# Access Compliance Report

## Public Rights-of-Way

### (Curb Ramps)

Intersection ID: 19904	Main Street: FALLOW_LN	Cross Street: THORNFIELD_RD	Location: SW
ADA ID: 63061ED1A36A	Ramp Type: BlendTrans2	Initial Pass/Fail: Pass	Overall Compliance: No
Severity Score: 22.5			
Codes/Mitigation Info/Possible Solution		Field Measurements/Component Compliance

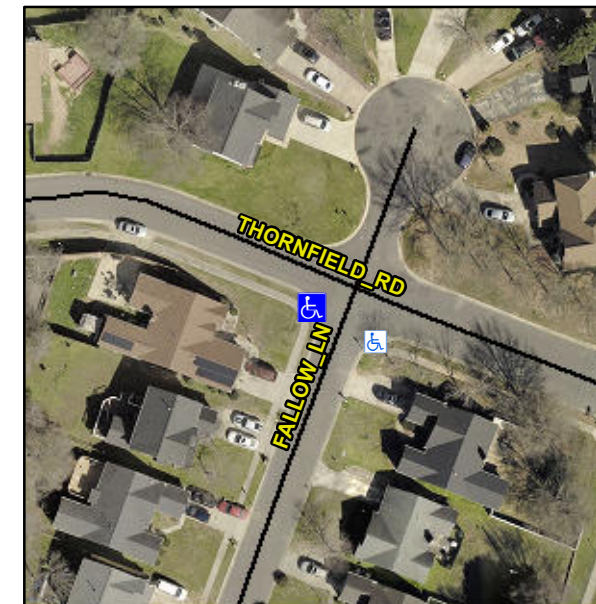
**Not Found, R305, R302.7.2, R304.5.4**

Compliance	Description	Data	Compliance	Description	Data
N/A	Ramp Length (in)	96.0	Yes	BlendTrans Slope (%)	3.4
Yes	Ramp Width (in)	87.0	Yes	BlendTrans XSlope (%)	0.6
N/A	Flare Type LT	Sloped	N/A	Flare Type RT	Sloped
N/A	Flare Slope LT (%)	2.7	N/A	Flare Slope RT (%)	1.1
N/A	Flare Traversable LT?	No	N/A	Flare Traversable RT?	No
N/A	Landing Length (in)	N/A	No	DWS Provided?	No
N/A	Landing Width (in)	N/A	N/A	DWS Contrast?	No
N/A	Landing Slope (%)	N/A	N/A	DWS Length (in)	N/A
N/A	Landing X Slope (%)	N/A	N/A	DWS Full Width?	No
N/A	Landing Curb? (Y/N)	No	N/A	DWS Offset (in)	N/A
N/A	Shared Landing?	No			
Yes	Gutter Ponding?	No	No	Gutter Slope (%)	11.7
No	Gutter Lip Ht (in)	0.5	Yes	Gutter X Slope (%)	0.4
N/A	Painted X Walk1?	No	N/A	Painted X Walk2?	No
	X Walk 1 Direction	To SE		X Walk 2 Direction	To N
	X Walk 1 Width (in)	N/A		X Walk 2 Width (in)	N/A
	X Walk 1 Slope (%)	3.5		X Walk 2 Slope (%)	3.7
	X Walk 1 X Slope (%)	4.0		X Walk 2 X Slope (%)	3.8

N/A	Ramp inside XWalk1?	N/A	N/A	Ramp inside XWalk2?	N/A
	Road Slope (%)	0.2		Clear Space?	Yes
	Road X Slope (%)	7.3	N/A	Clear Space to XWalk (in)	N/A
Yes	Any Obstructions?	No	Yes	Storm Grate/Utility Hazard?	No
	Obstruction Type			Storm Grate/Utility Type	
		N/A			N/A
			Yes	Surface Condition? (G/P)	Good
			No	Curb Slope (%)	5.3

**Remove & Replace Curb Ramp With Two New Directional Ramps or Equivalent. Remove & Replace Gutter.**
